Group of Experts on Road Signs and Signals

Report of the Group of Experts on Road Signs and Signals on its tenth session

A sign-by-sign assessment by the Group of Experts

A, 19 c “INTERSECTION WITH A ROAD THE USERS OF WHICH MUST GIVE WAY”

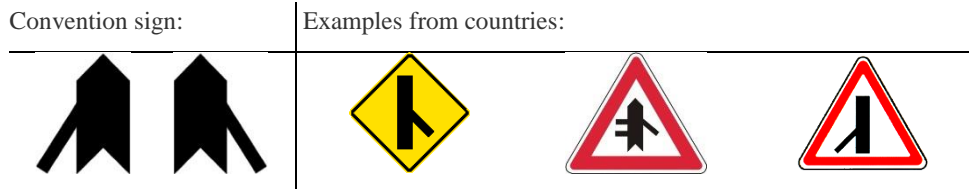
Some countries do not use the arrow head or the “V” shape at the bottom. The Group recommended using the symbol in the Convention without altering it (that is, having the arrow head and the “V” shape at the bottom). The Group clarified that the arrow head and the “V” shape at the bottom, and the differences in the proportion of the line widths, are essential characteristics of the symbol.

The Group suggested that the Convention should have as many examples of symbol A, 19 as it does for symbol A, 18.

A, 20 “INTERSECTION WITH A ROAD TO WHOSE USERS DRIVERS MUST GIVE WAY”

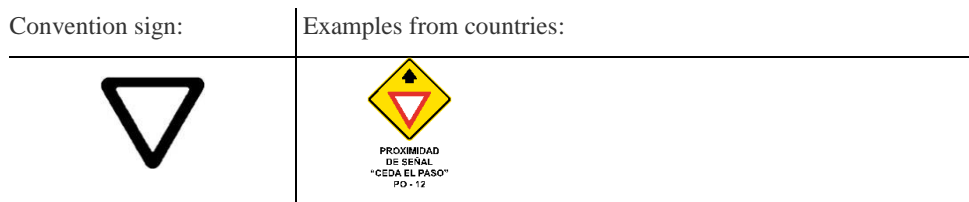
The Group noted that only a very few countries use the sign A, 20 while the majority of countries use the sign B, 1 with additional panel H, 1. This second possibility is introduced with paragraph 6 Article 10 (first sentence). However, the Group noted that both the paragraph 6 as well as point 20 (a) of Section A of Annex 1 require that the same warning is implemented by different signs both being obligatory.

The Group recommended that giving advance warning of B, 1 should be done in accordance with paragraph 6 Article 10 while the sign A, 20 should be removed from the Convention.

The Group further recommended that paragraph 6 of the European Agreement should be deleted (first sentence).

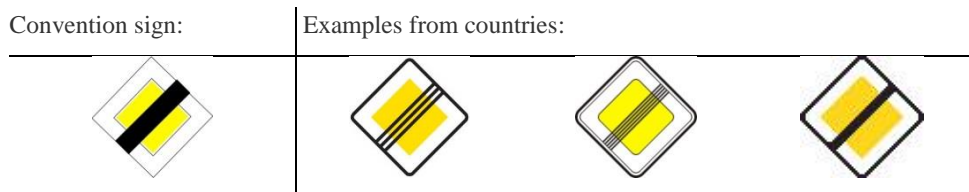
The Group recommended to amend the definition of sign B, 4 as follows:

The "END OF PRIORITY" sign shall be sign B, 4. It shall consist of sign B, 3 with the addition of a black median bar perpendicular to the lower left and upper right sides of the square or, preferably, of black parallel lines forming such a band.

Secretariat note: annex should show the B, 4 sign with three parallel lines.

B, 5 “PRIORITY FOR ONCOMING TRAFFIC”

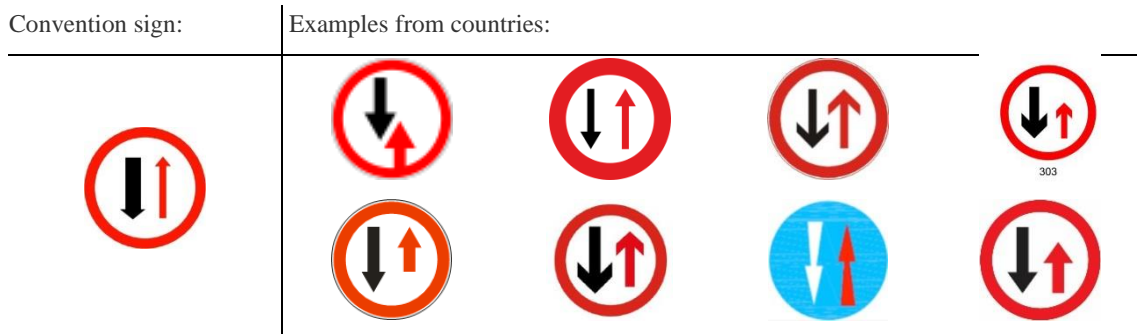
The Group noted that some countries do not use the arrows (ie length, width, positioning) as they appear in the Convention. The Group recommended that the arrowheads in the symbol used in Annex 3 of the Convention be enlarged, and that the signs of countries be in line with the revised symbol. The Group also recommended that the following additional words be inserted at the start of the article related to sign B, 5: “The sign indicating priority for oncoming traffic shall be sign B, 5.”

B, 6 “PRIORITY OVER ONCOMING TRAFFIC”

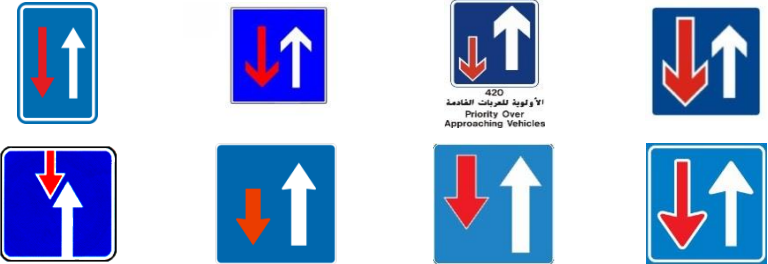
The Group noted that some countries do not use the arrows (ie length, width, positioning) as they appear in the Convention. The Group recommended that the arrowheads in the symbol used in Annex 3 of the Convention be enlarged, and that the signs of countries be in line with the revised symbol. The Group also recommended that the following additional words be inserted at the start of the article related to sign B, 6: “The sign indicating priority over oncoming traffic shall be sign B, 6.” To assist colour-blind drivers, the Group recommended that a white rim should be inserted around the red arrow.

C, 8 “NO ENTRY FOR VEHICLES HAVING A MASS EXCEEDING ... TONNES ON ONE AXLE”

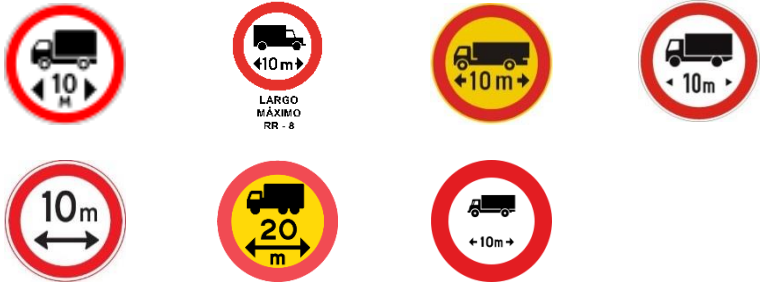
The Group noted that there was a difference in the casing of the symbol “T” (ie some countries use lower casing “t”), its positioning within the sign, and also that some countries used commas and period marks. The Group also noted differences in the arrowheads and axles. The Group believed that the symbol in the Convention should be modified from upper to lower casing (“t”) and that the positioning of the symbol “t” should appear where it currently appears in the Convention. The group also believed that the arrow should be deleted, replaced by one arrowhead and that the number used for the first digit in the Convention symbol should be larger.

Finally, the Group believed, that where a comma or period mark is used, that the second digit should be two-thirds the size of the first digit, and that the lower casing “t” should appear immediately after the second digit and at the same level, and be proportionately visible. If a fraction is required, the Group believed that it should be to the nearest tenth (ie

3.5t, 7.8t). If it is an integer (ie 7.00t), it should appear without any zeros or period marks (ie 7t).

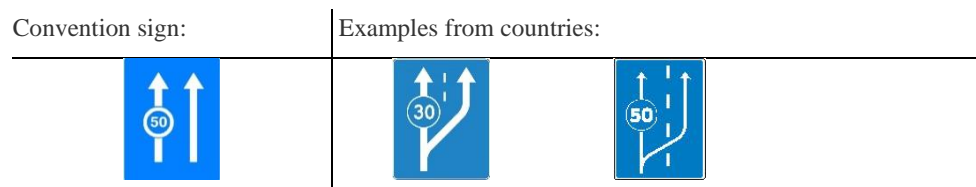
Many countries use road markings (broken line) on this sign. The Group recommended the symbols on this sign not to include road markings ie., broken lines as the arrows indicate the “lanes”.

The Group recommended that for the E, 1 b sign the sign D, 7 is used with a white rim.

E, 1 c “SPEED LIMITS APPLYING TO DIFFERENT LANES”

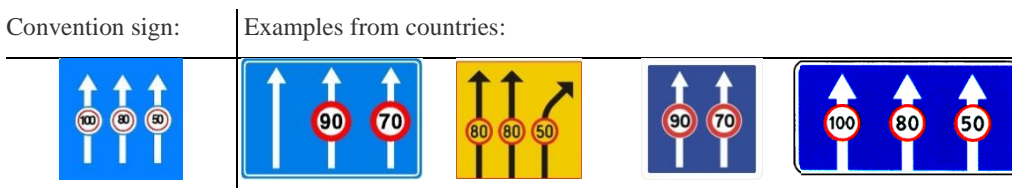
Azerbaijan used a wrong example for E, 1 c sign (truck entry prohibition sign instead of speed limit sign).

The Group recommended that the E, 1 c sign is improved by placing the sign C, 14 on the arrows and adding a white rim.

E, 2 a “SIGNS INDICATING LANES RESERVED FOR BUSES”

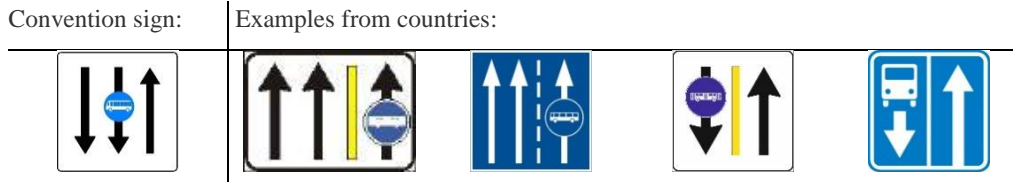
Article 26bis paragraph 2, Section E, sub-section II, point 2 and E, 2 a and E, 2 b reproductions in Annex 3 do not appear to be consistent and thus do not clearly define signs E, 2 a and E, 2 b.

Several countries (Azerbaijan, Belgium, Croatia, Latvia, Luxembourg, Montenegro and Ukraine) use examples for E, 2 a that do not correspond to the examples of the Convention.

Many countries use road markings (broken or continuous line) on this sign. The Group recommended the symbols on this sign not to include road markings as the arrows indicate the “lanes”.

E, 2 b “SIGNS INDICATING LANES RESERVED FOR BUSES”

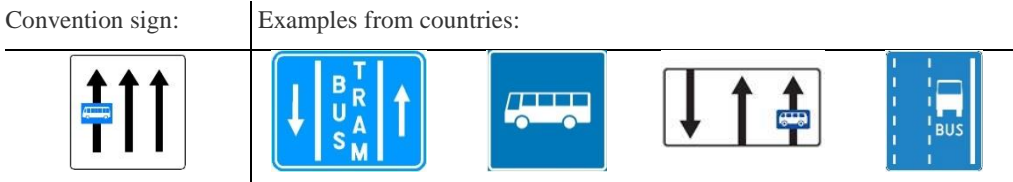
Several countries (Belgium, Croatia, Finland, Latvia, Montenegro, Poland and Ukraine) use examples for E, 2 b that do not correspond to the examples of the Convention.

Many countries use road markings (broken or continuous line) on this sign. The Group recommended the symbols on this sign not to include road markings as the arrows indicate the “lanes”.

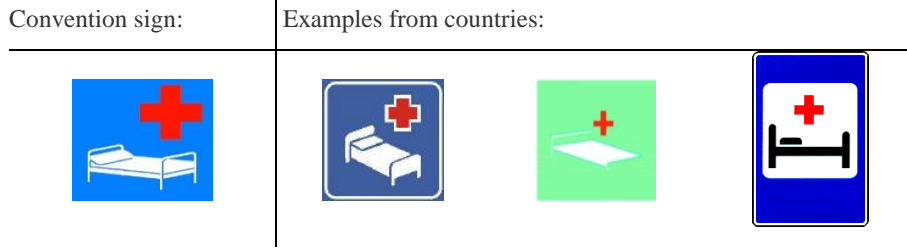
The Group recommended to replace the E, 13 b bed symbol with the bed symbol used by, for example, the Russian Federation.

One country (Nigeria) uses a green ground on the E, 13 b sign, which is not in conformity with the Convention.

E, 14 a “PARKING”

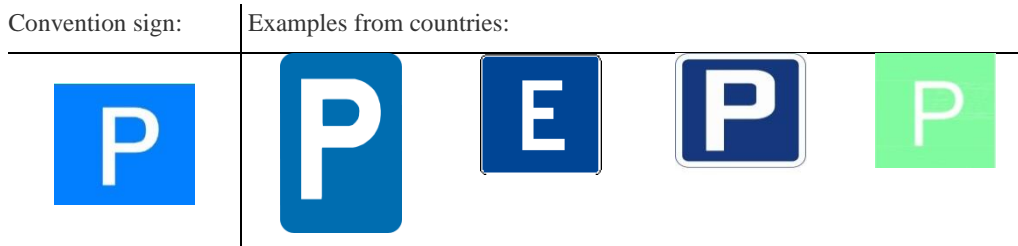
All countries use the same design of sign in accordance with the Convention. There are very slight difference of symbol and the tone of blue background used in the Convention. One country (Nigeria) uses the dark green colour on the sign as ground.

The Group recommended that the use of letter P to denote parking is a preferred option (and required in the Contracting Parties to the European Agreement). However, the Group recognized the extensive use of letter E on other continents.
